NO-01-307
December 14, 2001

SUBJECT: **Quality Assurance Program (QAP) Topical Report - Millstone Power Station Revision 23, Change 3 (Document No. MP-02-OST-BAP01)**

Summary of Changes to QAP Rev. 23 Incorporated as Change 03

Organizational Relationship
of Functional Groups Having Quality
Functions for Millstone
Power Station

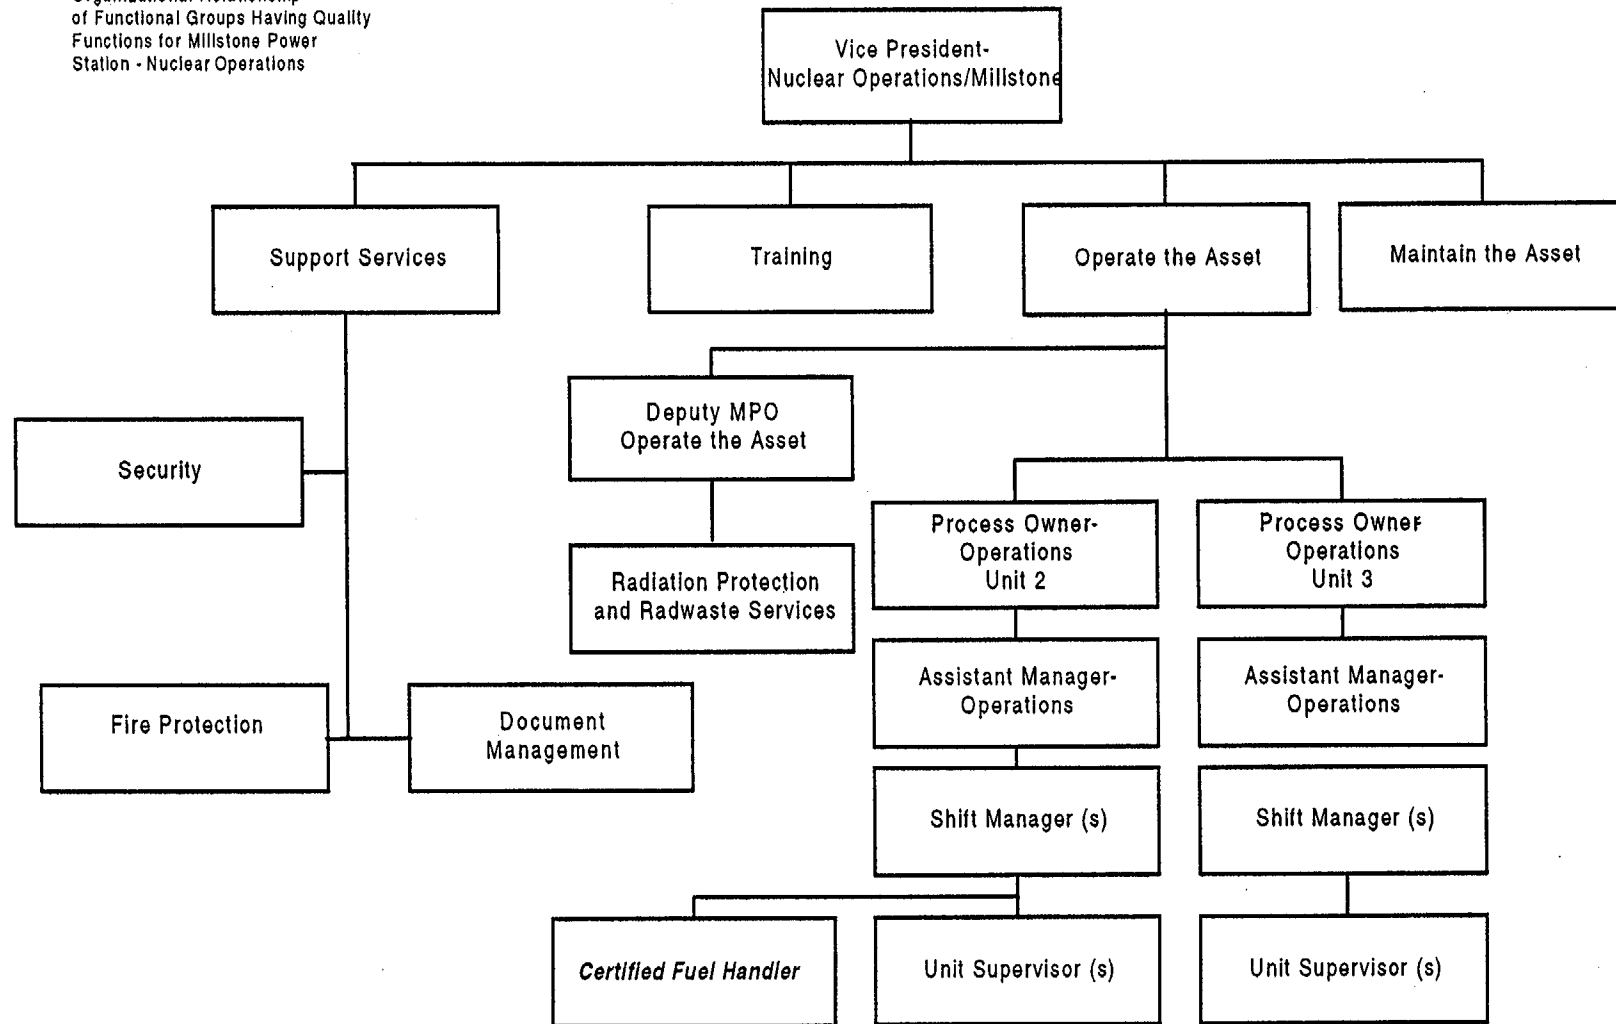
<u>Section</u>	<u>Summary Description of Changes</u>	<u>Reference</u>
Section 1.0	Modified Section 1.3.3 and Figure 1.1 to rename "Procure the Asset" to "Supply Chain Management" and "Master Process Owner - Procure the Asset" to "Director - Supply Chain Services" to align with Dominion Corporate titles	Request 01-12
Section 2.0	Renamed "Procure the Asset" to "Supply Chain Management" to align with Dominion Corporate titles	Request 01-12
Section 4.0	Renamed "Procure the Asset" to "Supply Chain Management" to align with Dominion Corporate titles	Request 01-12
Section 7.0	Renamed "Procure the Asset" to "Supply Chain Management" to align with Dominion Corporate titles	Request 01-12
Section 8.0	Renamed "Procure the Asset" to "Supply Chain Management" to align with Dominion Corporate titles	Request 01-12
Section 9.0	Renamed "Procure the Asset" to "Supply Chain Management" to align with Dominion Corporate titles	Request 01-12
